INDEX OF SHEETS		SHEET No.
TS01	TITLE SHEET	01
GN01	OVERALL SHEET KEY	02
GN02	GENERAL NOTES	03
RD01-RD07	ROADWAY PLAN & PROFILE	04-10
SDGN01	STORM DRAIN SHEET KEY	11
SDGN02	STORM DRAIN GENERAL NOTES & DETAILS	12
SD01-SD05	STORM DRAIN PLAN & PROFILE	13-17
DFGN01	DETENTION POND GENERAL NOTES	18
DF01-DF04	DETENTION POND 1 SITE PLAN	19-22
WT01	WATER CISTERN PLAN & DETAILS	24

HAY CREEK VALLEY

CONSTRUCTION DOCUMENTS

SEPTEMBER 2023

DETENTION POND PLAN
H: 1"=40'

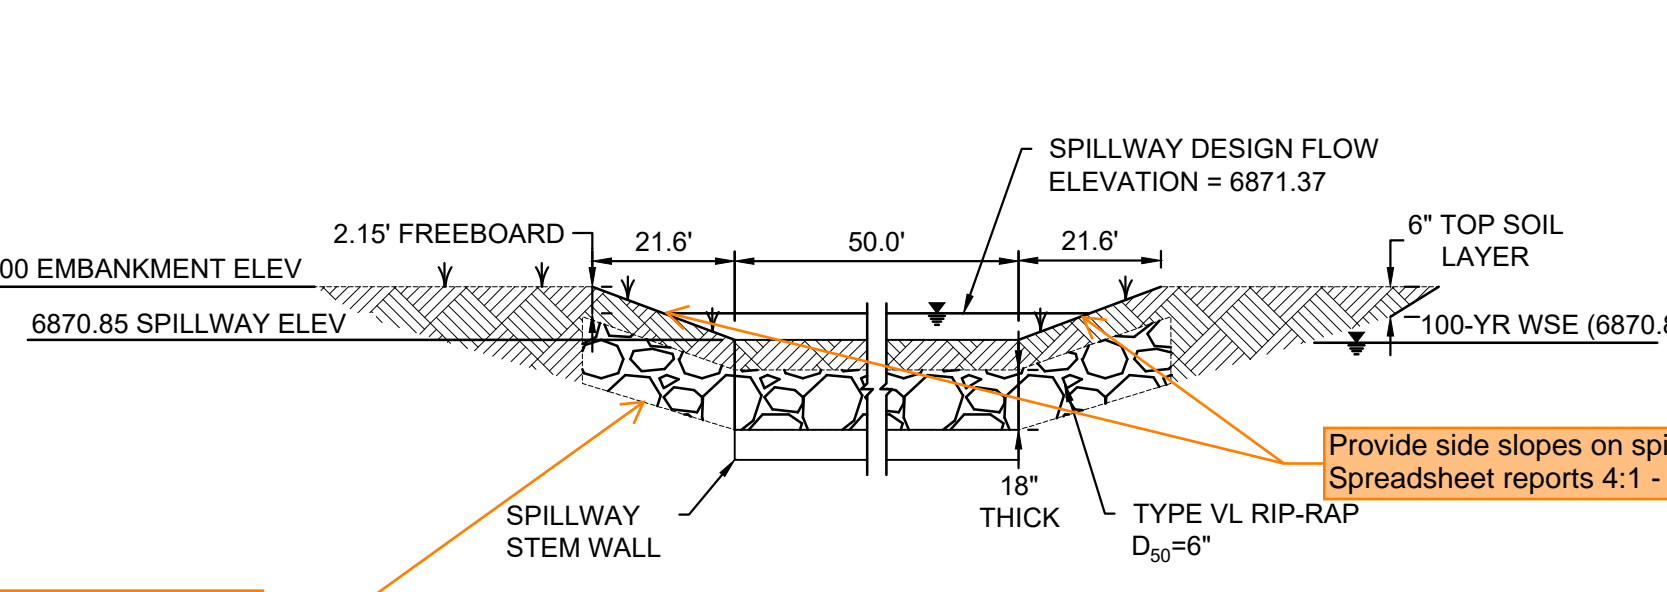
Soils Report states that ponds shall have 5:1 slopes. Update to match the geotech recommendations.

Pond bottom should have a minimum slope of 3% to the trickle channel and micropool (USDCM Vol 3, detail T-5). Please adjust to minimize future maintenance needs.

Stabilized access ramp shall be a minimum of 15ft wide, in accordance with DCMv1, Chap 11.2.2.

Include signage for pet waste station(s) around the pond, with text stating that pet waste must be picked up.

FOREBAY STEM WALL ELEVATION

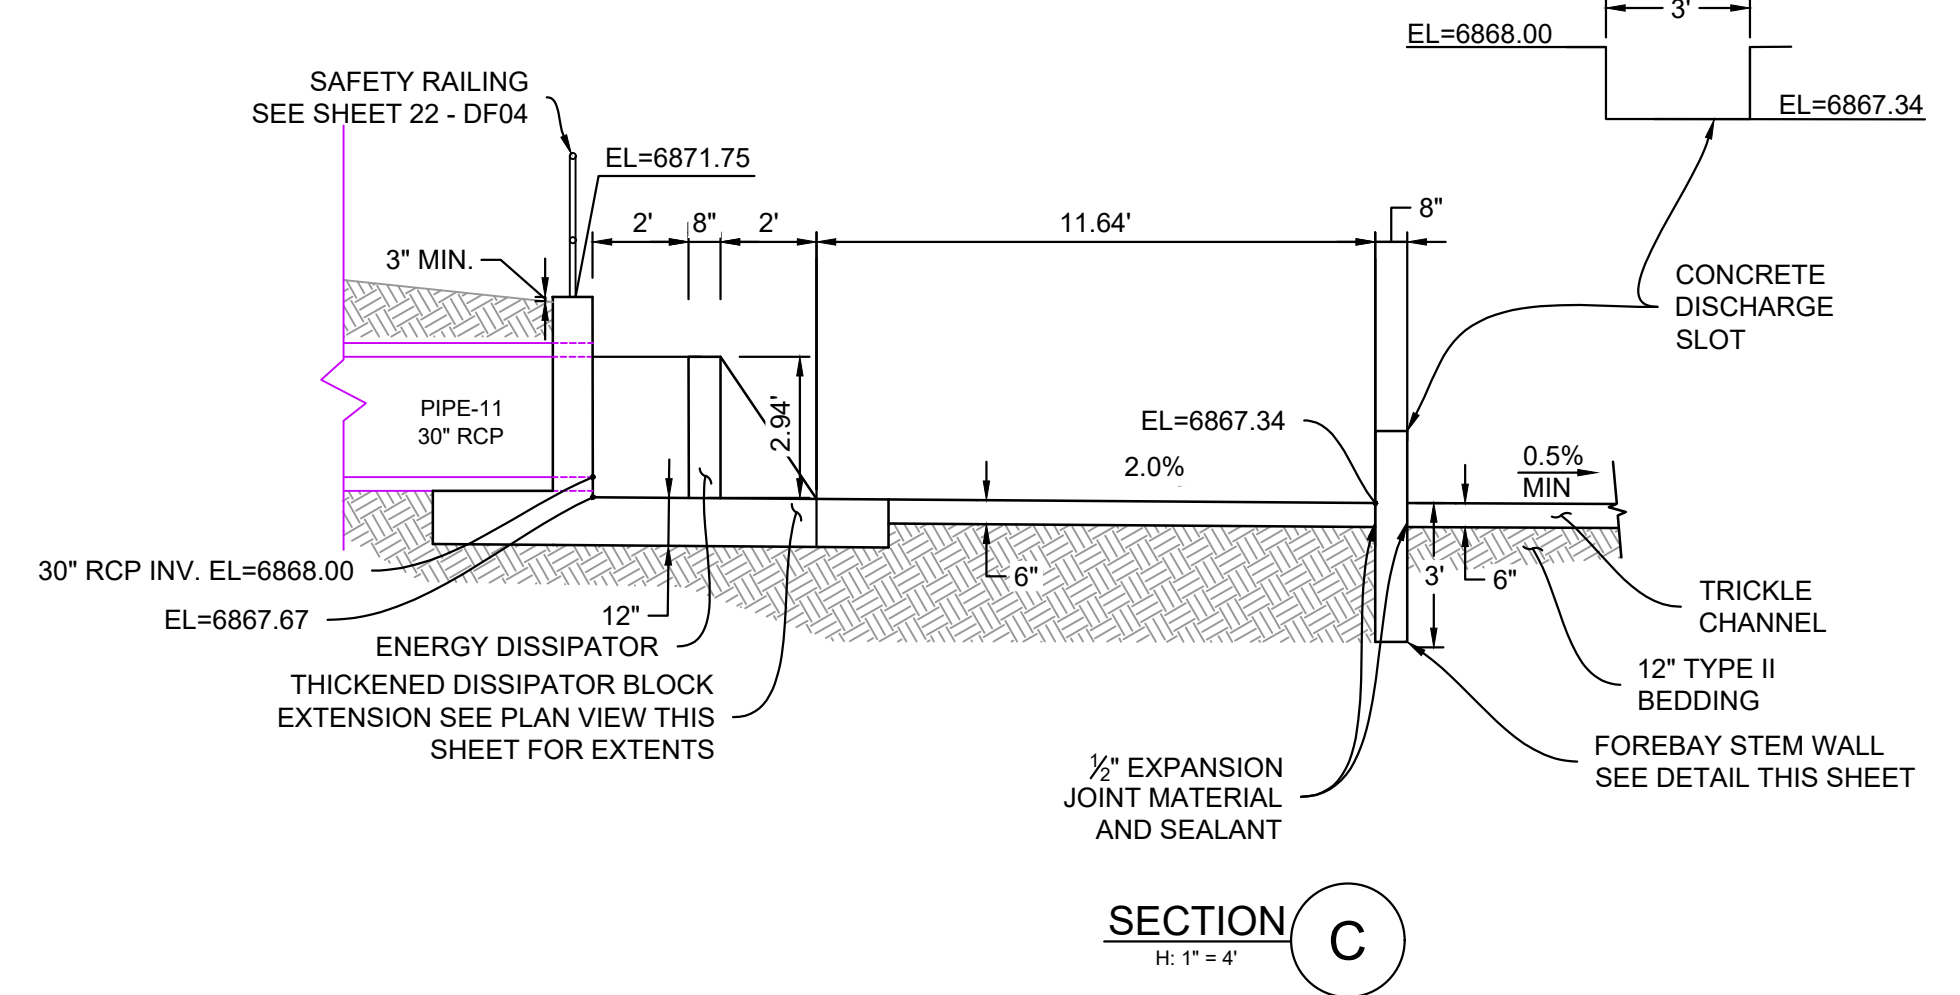
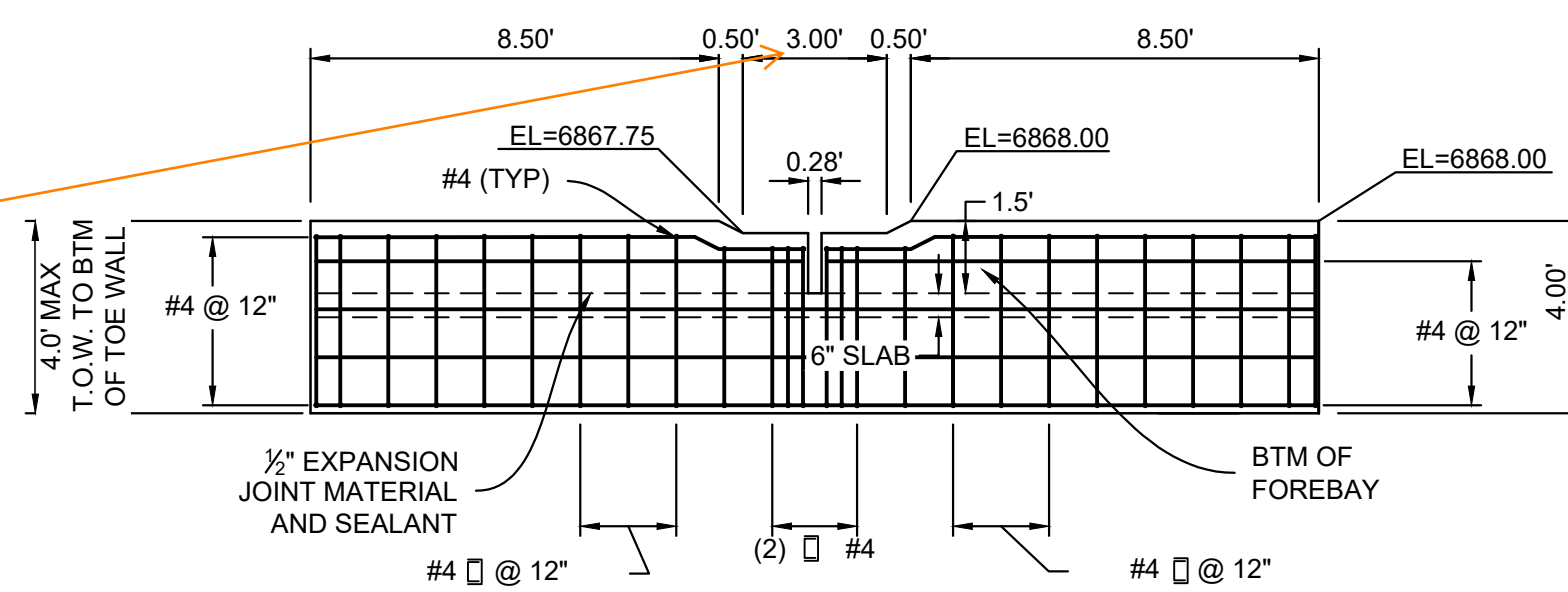
Internal note: review forebay design once forebay sizing calcs are provided in the FDR with the next submittal.

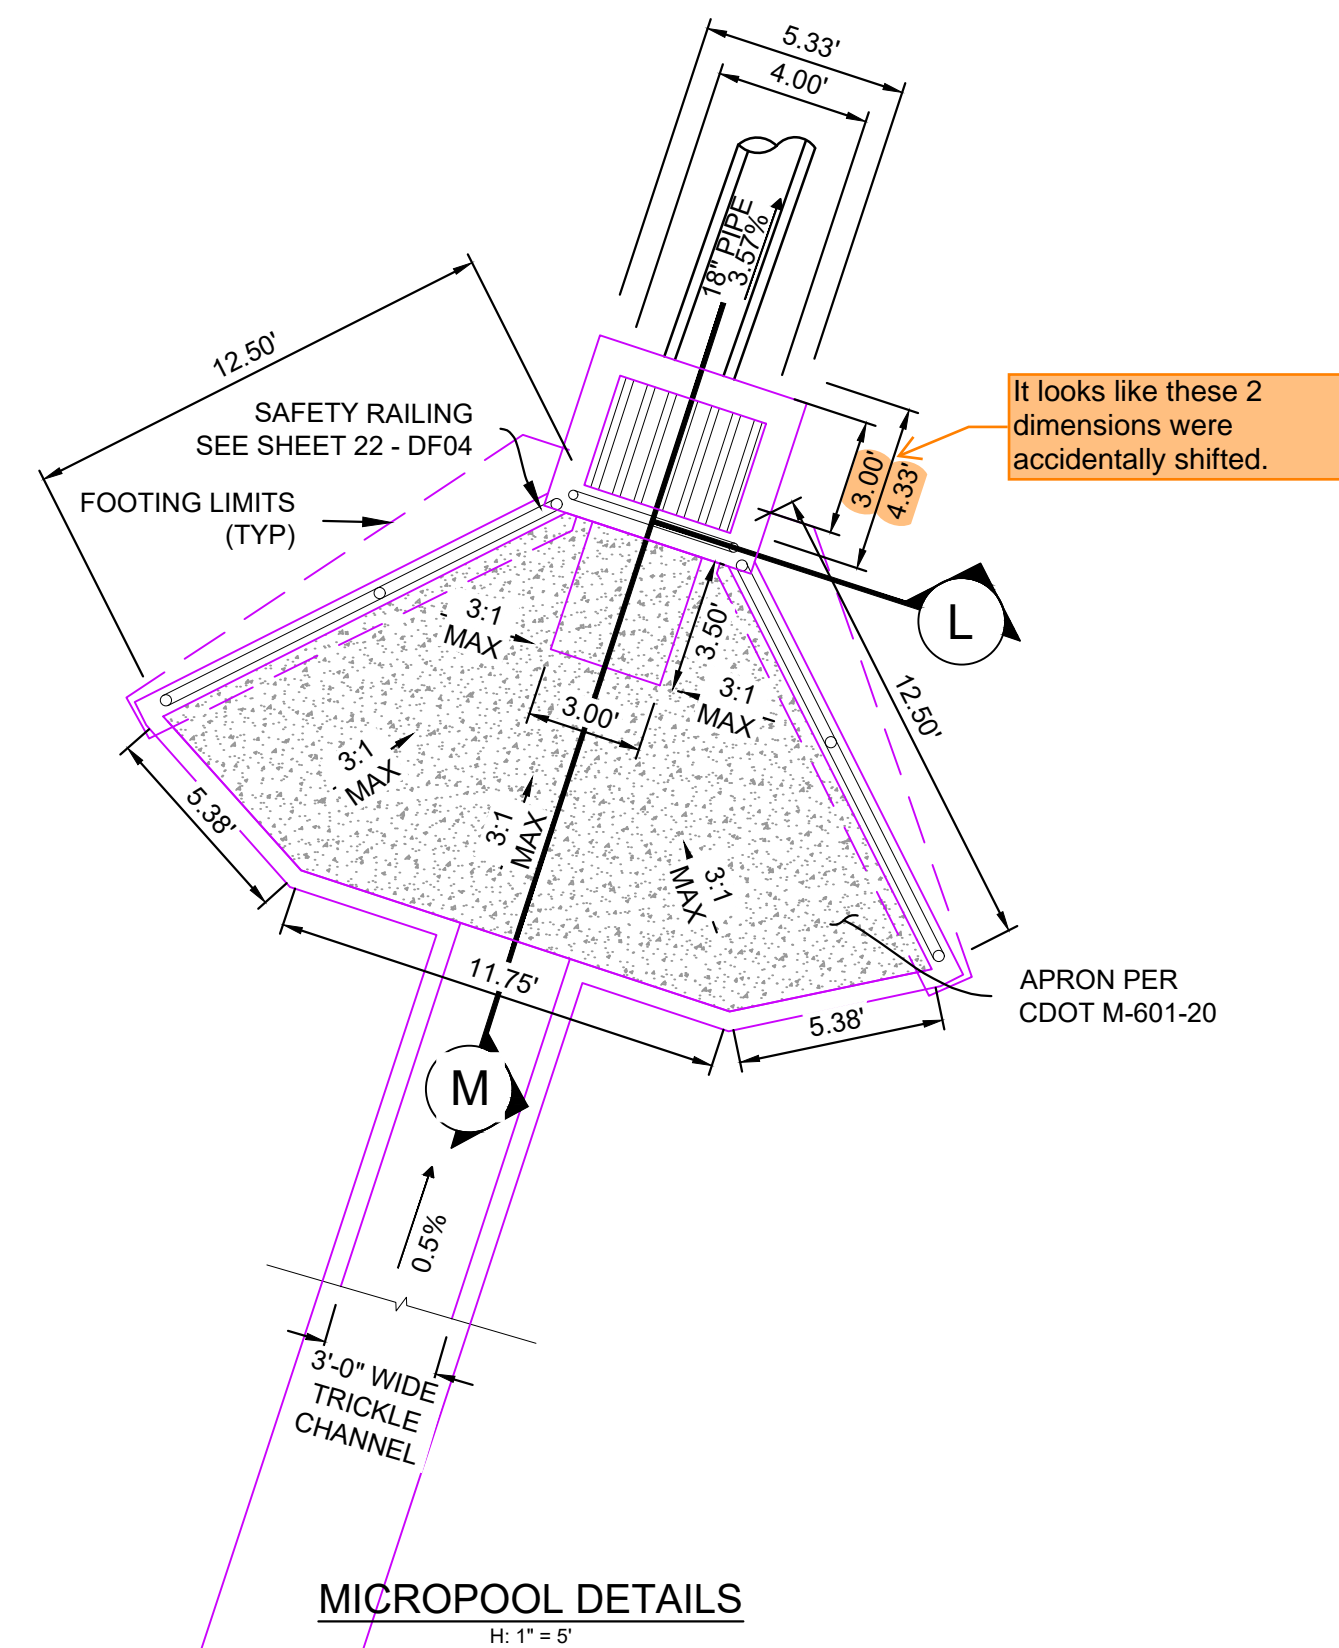
According to the MHFD-Detention spreadsheet on PDF pg 41 of the FDR, this elevation is supposed to be at the invert of the orifice. On this detail it is labeled as the centroid via the leader line arrow and the dimension line.
